**ADDENDUM TO THE
FEASIBILITY STUDY REPORT**

**CHEMICAL COMMODITIES, INC. SITE
OLATHE, KANSAS**

Subject: Addendum to the Feasibility Study Report
Chemical Commodities, Inc. Site
Olathe, Kansas

**Response to Conditional Approval of the Draft Feasibility Study Report
Dated May 6, 2004**

FIGURE 1
 SOIL ALTERNATIVE S3D
 EXCAVATION AREA 0-6 ft-bgs

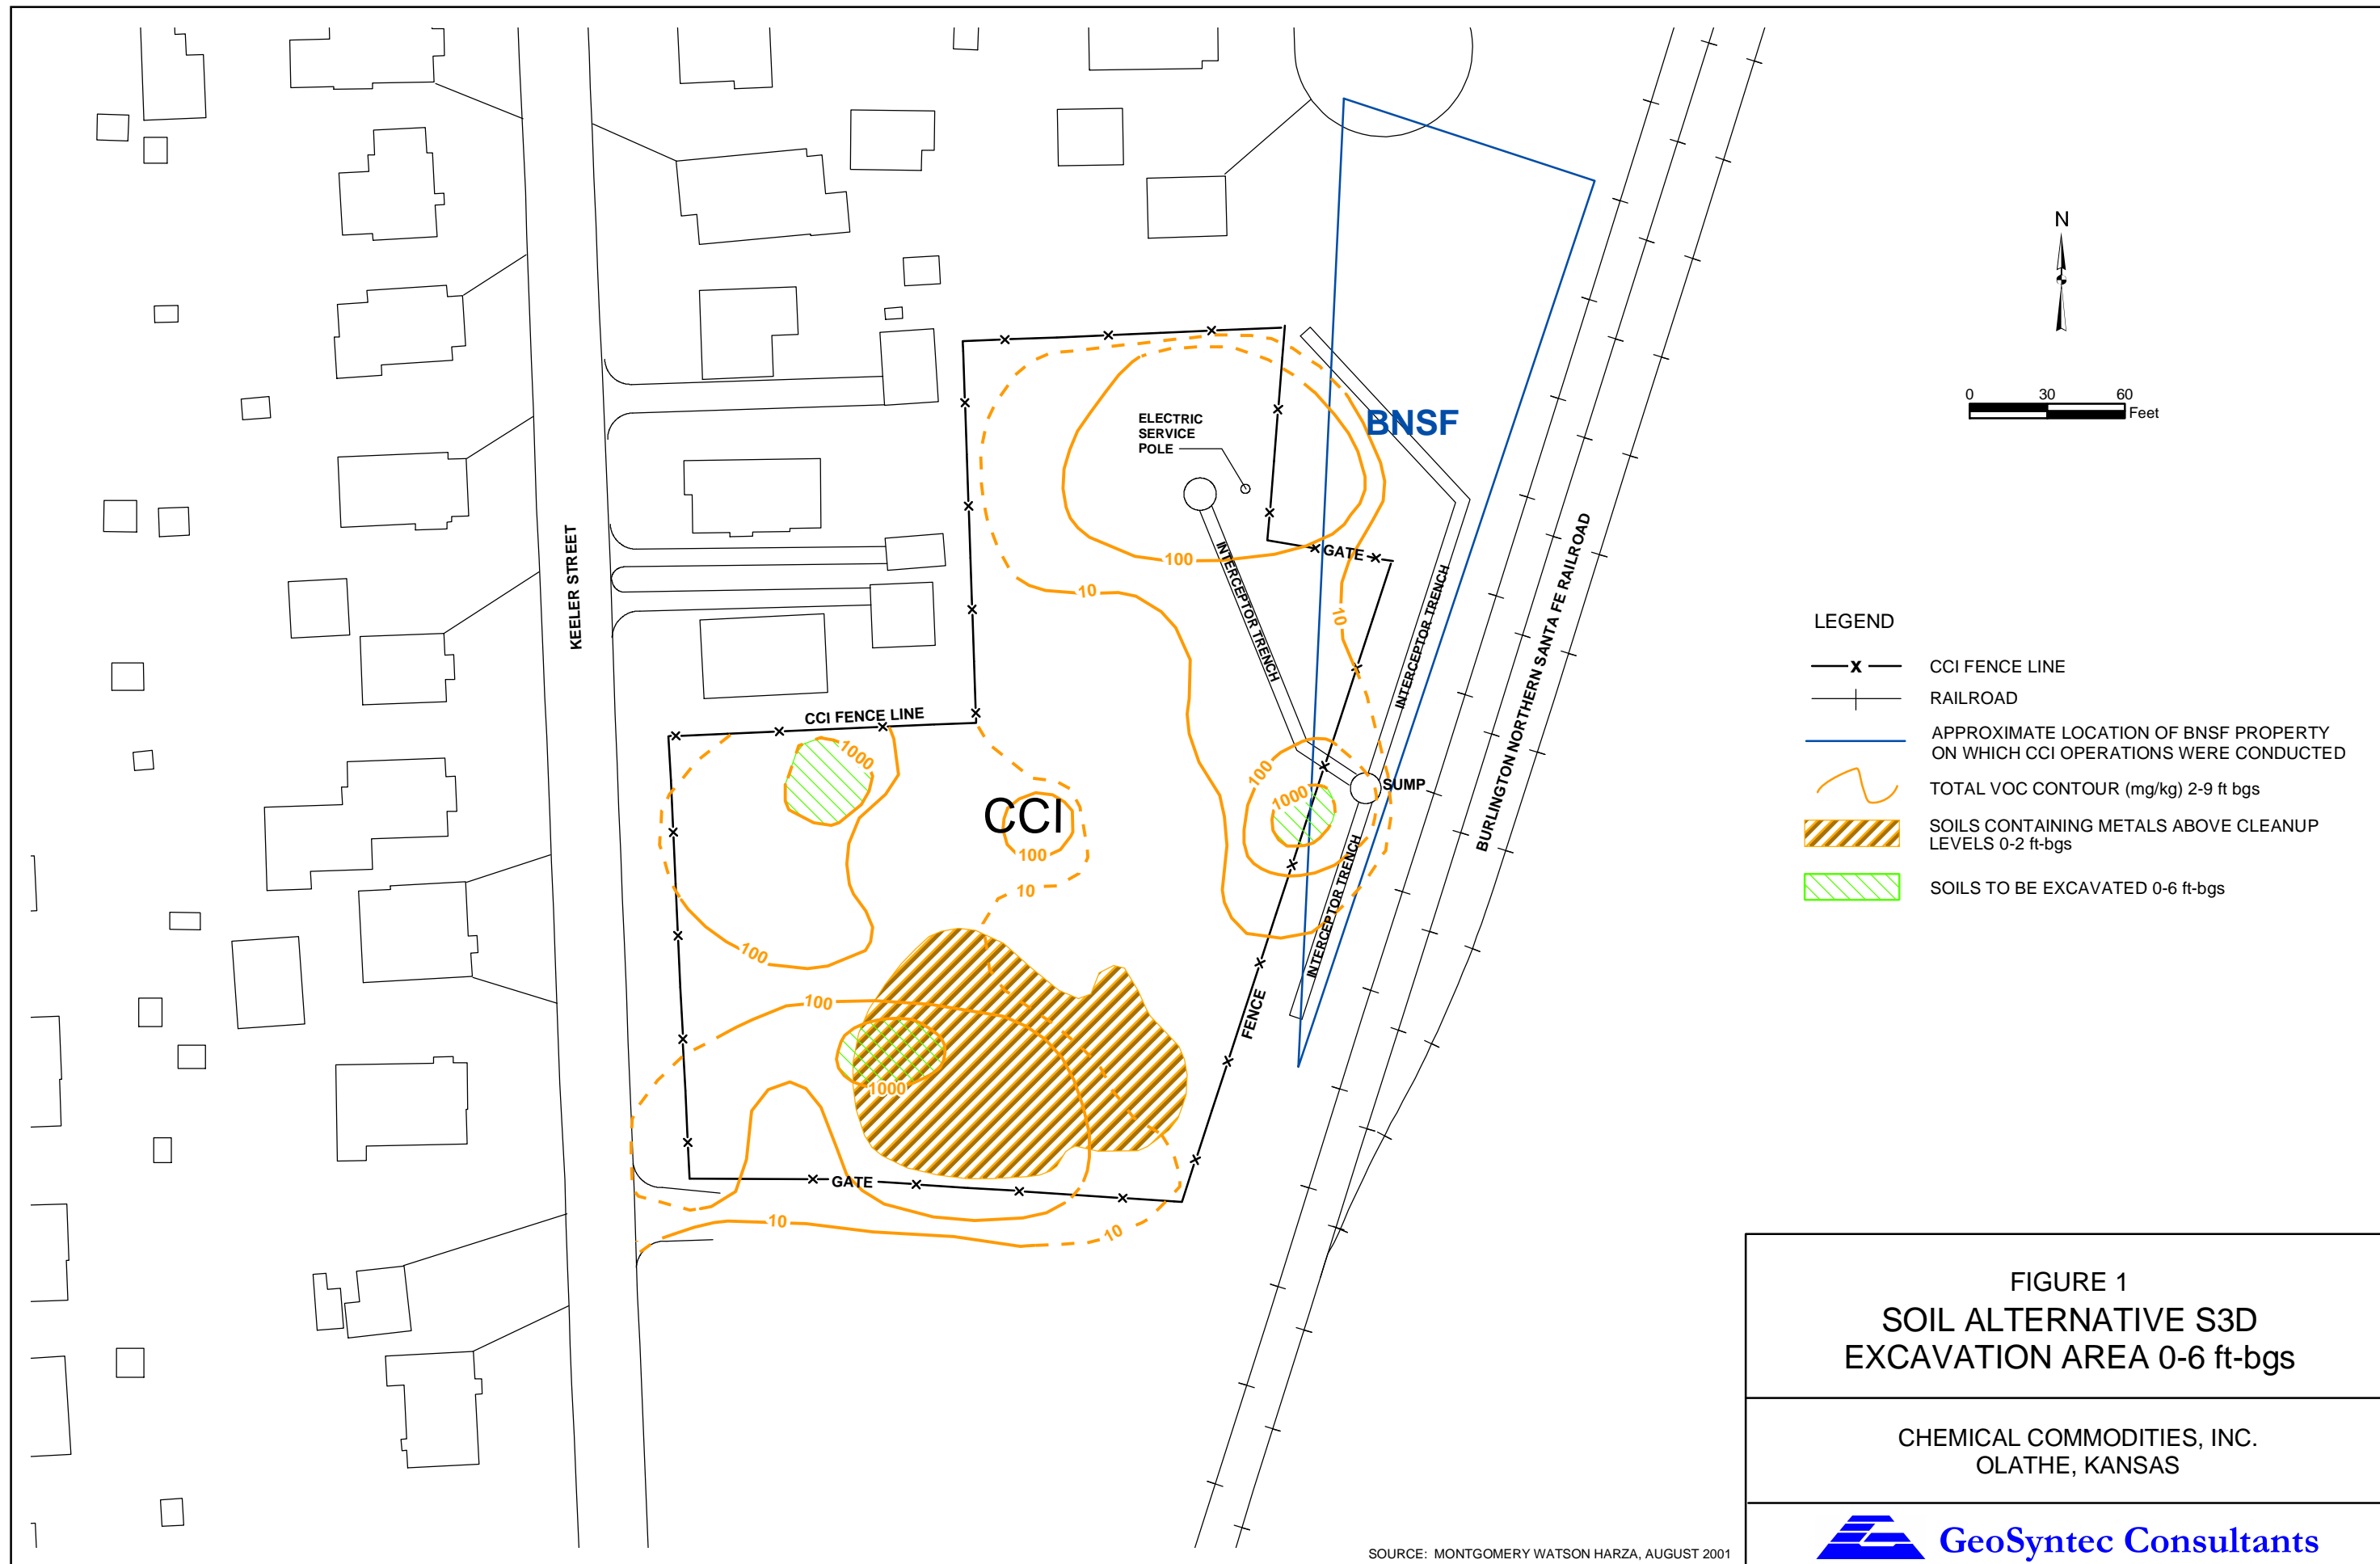
Comment 2. The EPA believes that an additional excavation scenario should be evaluated to focus on hot spots as defined by the soil contour maps. The EPA envisions that the excavation would be conducted in cells where the cells are designed to maximize mass removal, while minimizing exposure to area residents through the use of methods such as enclosures around the cell. All excavation scenarios for offsite disposal should be evaluated for transportation by rail, provided that the railroad can assist by defining certain considerations in a timely manner. My contact at Burlington Northern Santa Fe (BNSF) is Judy McDonough. Judy can be reached at (913) 551-3989 or via e-mail at "judith.mcdonough@bnsf.com".

Response: An additional excavation scenario has been developed and incorporated into a new alternative for the FS Addendum. This alternative, identified as soil alternative scenario S3D, is provided as a section of this FS Addendum. The alternative includes excavation of VOC-contaminated soil above a concentration of 1,000 ppm to a depth of six feet below ground surface (bgs) and metals-contaminated soils that present a human health risk at the Site, also to a depth of six feet bgs. These soils would be transported off-Site for disposal. Clean soil would be imported and compacted for backfill of the excavation and the Site would then be graded and capped. The actual design elements of the cap would be decided during remedial design, and would be chosen so that a wide variety of open space uses could be accommodated. Land use restrictions would be

- Clear and grub the Site of remaining vegetation and debris.
- Excavate soils containing VOCs above a concentration of 1,000 ppm to a depth of six feet bgs and metals-contaminated soils that present a human health risk at the Site also to a depth of six feet bgs within the footprint shown on Figure 1.

In soil alternative scenario S3D, the top six feet of metals-contaminated soil and VOC-contaminated soil would be excavated within the footprint shown on Figure 1. Such an excavation would remove an estimated 50% of the mass of VOCs contained in vadose zone soils as well as metals-contaminated soils that exceed human health risk levels. VOCs remaining in Site soils would attenuate over time.

Figure 1 presents the area of soils that would be excavated for off-Site disposal overlain with the total VOC concentrations from the 2 to 9 foot depth. TCE has been identified to comprise a majority of the VOC mass in impacted soils. As shown in Figure 1, a significant portion of the soils to be excavated likely contain concentrations greater than 10 ppm, of which some are likely greater than 60 ppm. Therefore, for FS Addendum purposes, it is assumed that of the total soil volume to be disposed (2,500 CY), 50% (1,250 CY) would require incineration, 40% (1,000 CY) would be classified as hazardous waste but would not require treatment before disposal in a Class A landfill, and the remaining 10% (250 CY) would be non-hazardous and would be disposed in a Class C landfill.
